SB-10053604-1203

SI M13 01 13
Fuel Systems

N14 and N18 Engine: High-pressure Pump Repair Instruction

**Continental High-pressure Pump (1):**

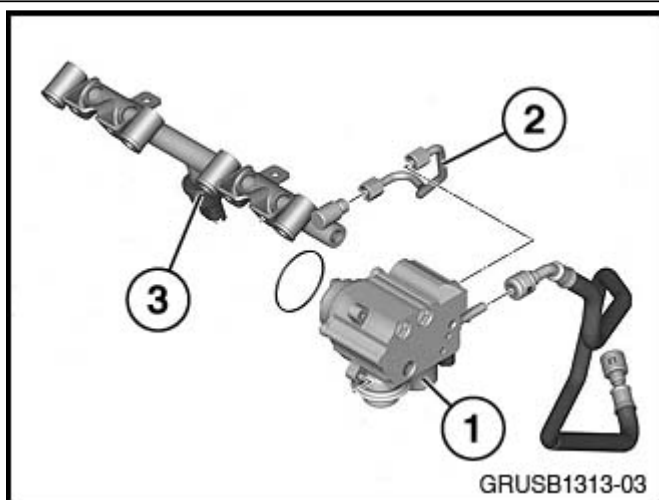
The current version of ISTA/D Repair Instruction 13 51 017, “Removing and installing or replacing high-pressure pump (N14, N18)” has a procedure error. The current version of the Repair Instruction states to replace the high-pressure supply hose on the N14 engine. The Repair Instruction also states not to replace the high-pressure supply hose on the N18 engine. The N18 portion of the Repair Instruction is incorrect. As an interim solution, follow the procedure outlined below until this portion of the Repair Instruction is corrected.

When the N18 engine is fitted with a Continental High-pressure Pump (1), the high-pressure supply hose (2) **MUST** be replaced when making repairs.

Bosch High-pressure Pump (1):

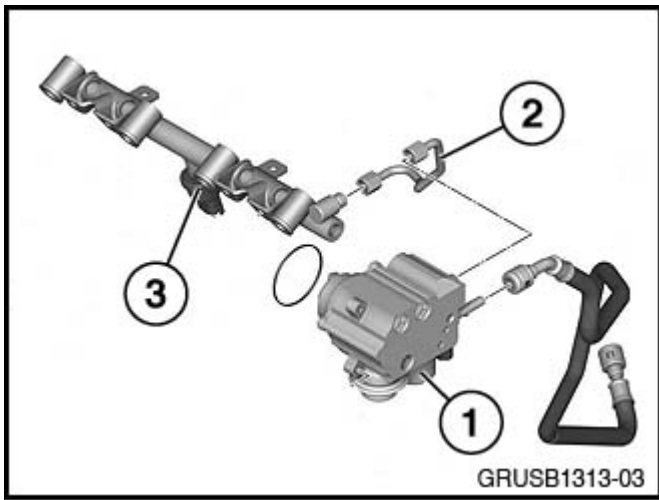
When the engine is fitted with a Bosch High-pressure Pump (1) the high-pressure supply hose (2) **MUST NOT** be replaced when making repairs.
